ADDENDUM NO. 2

PROJECT NAME: Selleck Skywalks
UNL PROJECT NUMBER: C341P002

DATE OF ISSUANCE: 01/31/2012
DATE OF BID OPENING: 02/03/2012

REVISED FLOOR FRAMING PLAN

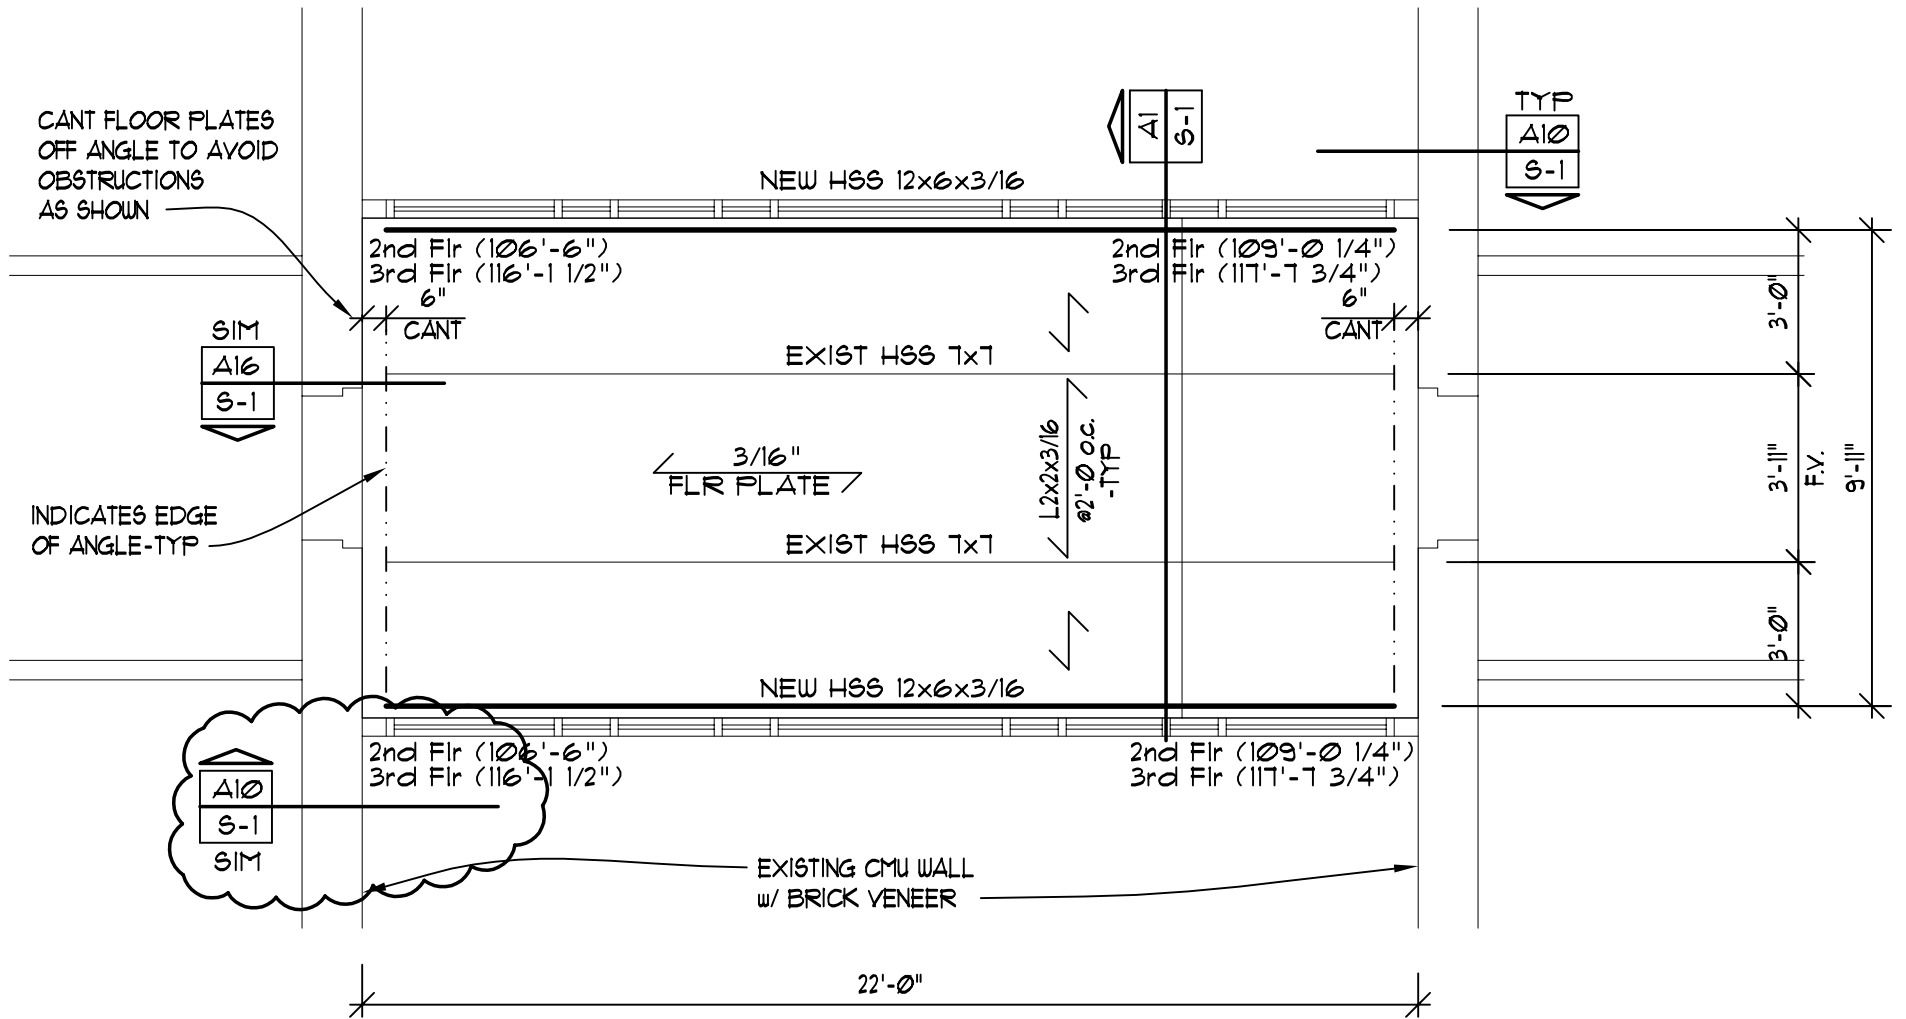
Correction: The structural steel beams must be pocketed into both existing walls but the interior of the building will not be accessible, therefore, the beams must be field welded once both ends are set in place. Refer to the attached revised structural details SK1 and SK2 for this change.

TYPICAL THIRD LEVEL FLOOR PLAN - LIGHTING

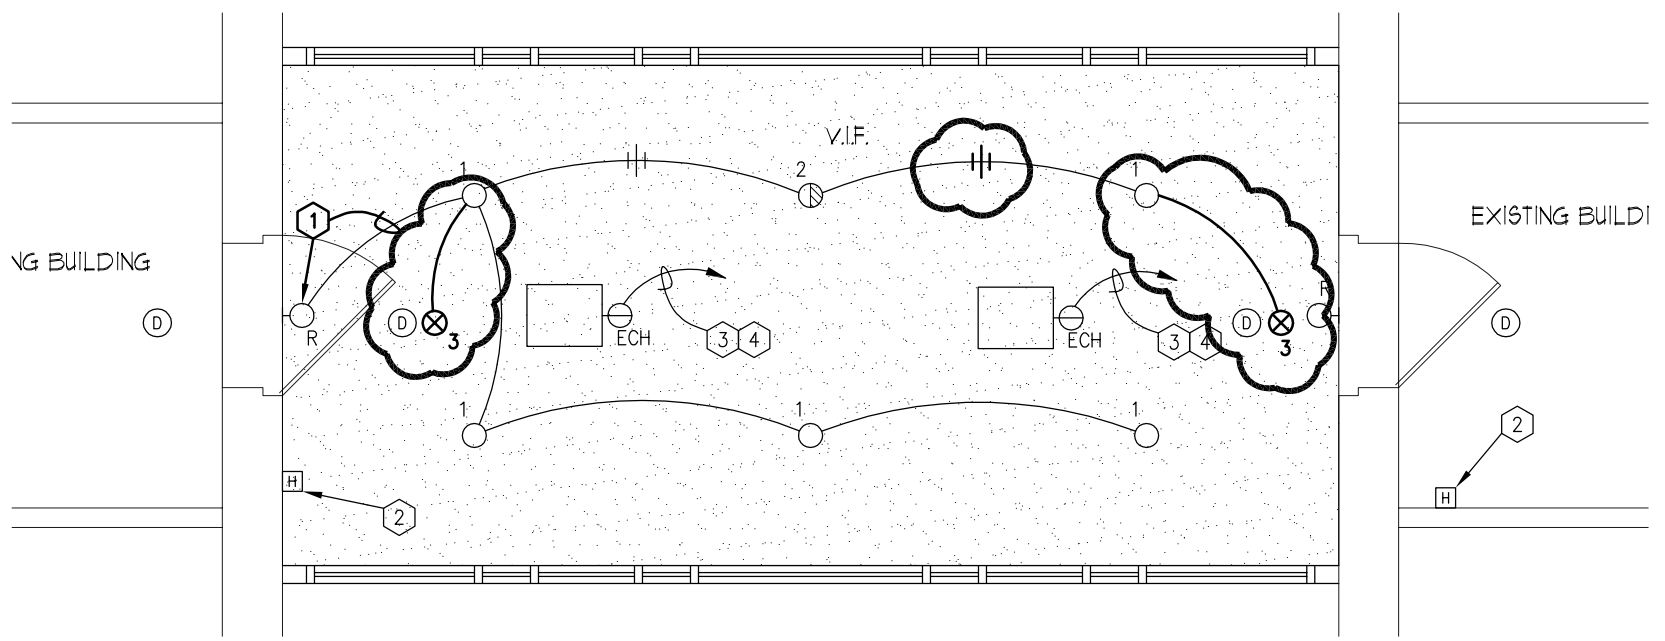
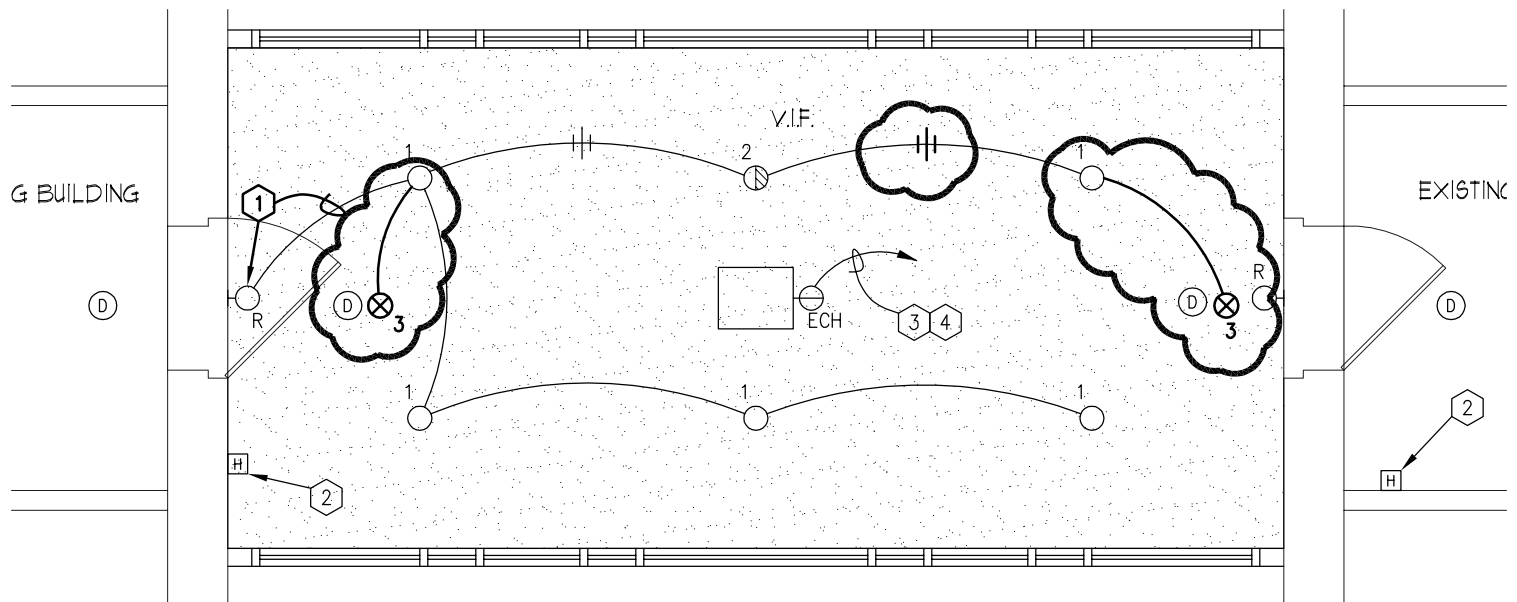
Correction: Sheet E-1 – Floor Plans – Lighting. Provide exits signs at each end of the skywalk. See Sheet E-1, Attachment 1E for more information.
